UNITED STATES PATENT AND TRADEMARK OFFICE

10/064,922

Office Action Summary

HAWKINS ET AL.

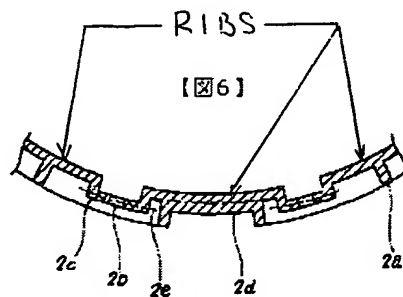
Re claims 1, 6, 10, 16 and 19, Japan'085 is cited disclosing a basket for a washing machine said basket comprising:

a substantially cylindrical outer wall (2c) and a plurality of inwardly projecting ribs depending therefrom (see fig. 6 below)

wherein, said outer wall includes a plurality of apertures (2b) there through, said apertures arranged in single vertically aligned columns between adjacent ribs: and

wherein said rib comprises a first side and a second side, said basket further comprising at least one circumferential support band (22a,) extending between said first side and said second side, said band extending from said outer wall that differs from the claims only in the recitation of the ribs having either
